# Performance Bulletin

December 2006

## Cam Changes on 9000/9100/9500 Valves

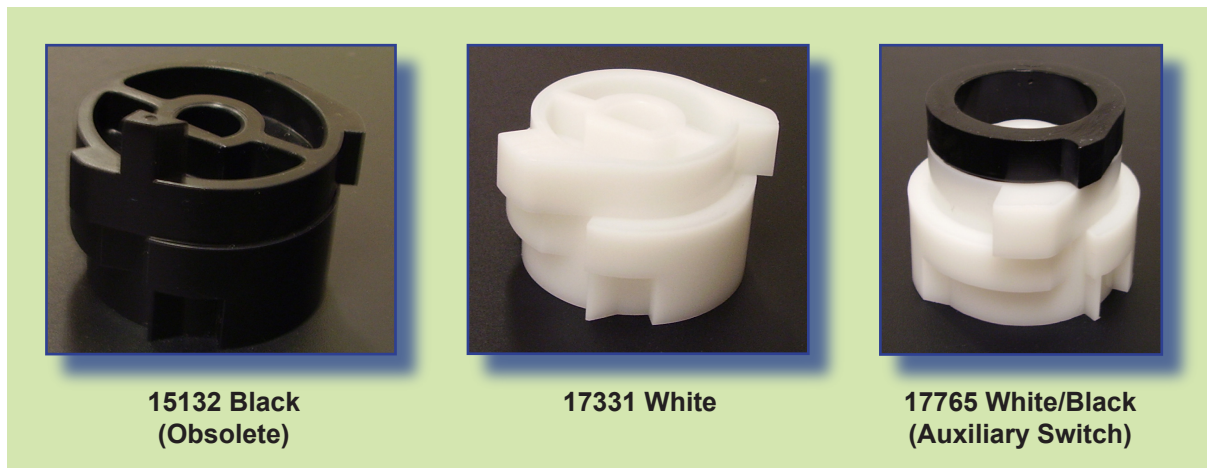
The 60320-09 auxiliary switch kit (Switch Assy, 9000/9100, Black Triple Cam) can only be used if the valve has the black cam (part number 15132) or a white/black cam (part number 17765). The 60320-10 auxiliary switch kit (Switch Assy, 9000/9100/9500, White Triple Cam) will include the 17765 cam and must be ordered if the valve has the white cam (part number 17331). (Please reference the chart below)

Part No.	Description	Cam Included in Kit?	Current Cam on Valve
60320-09	Switch Assy, 9000/9100, Black Triple Cam	N/A	15132 (Black) or 17765 (White/Black)
60320-10	Switch Assy, 9000/9100/9500, White Triple Cam	Yes (17765, White/Black)	17331 (White)
